Objection to Proposed CDM Status for 600 MW Upper Marsyangdi Hydro Power Project in the Manang and Lamjung Districts of Nepal

From: Himanshu Thakkar and Samantha Agarwal, South Asian Network on Dams, Rivers, and People, ht.sandrp@gmail.com, www.sandrp.in

Appendix 1

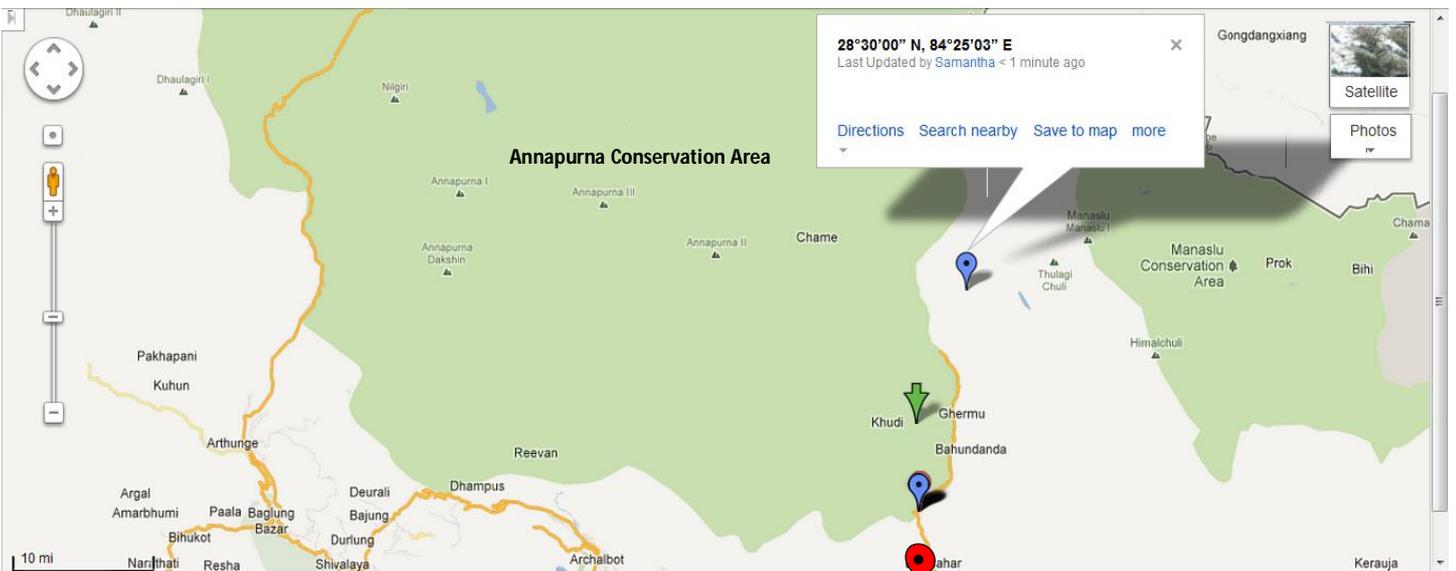
8. The project site is situated amidst the Gandaki Zone of Western Nepal. The dam, specifically, would be constructed between two important wildlife conservation zones, the Annapurna Conservation Area Project (ACAP) to the West, which is the largest conservation zone in Nepal, and the Manaslu Conservation Area to the East (see **Appendix 1 for Google Map Image**). Additionally, as per the PP’s own coordinates provided in the PDD *the power house of the UMS-2 seems to actually come within the ACAP*. Both ACAP and MCA harbor rare and endangered wildlife species such as the Snow Leopard, Musk Deer, Tibetan Argali, Impeyan Pheasant and Tragopan Pheasant. The company has provided no evidence of conducting a thorough impact assessment of how the proposed project would affect habitat and migration patterns of existing species, nor have they provided evidence of adhering to established laws dealing with wildlife such as the National Parks and Wildlife Conservation Act (1973). The project is thus legally questionable and environmentally harmful, the assessment of full impacts not even done.

According to the geographical coordinates provided in the PDD of UMS-2, the site of the power house (represented by the red marker) seems to be inside the Annapurna Conservation Area, whereas the site of the dam (represented by the blue marker) appears to be less than 10 km east of the same.
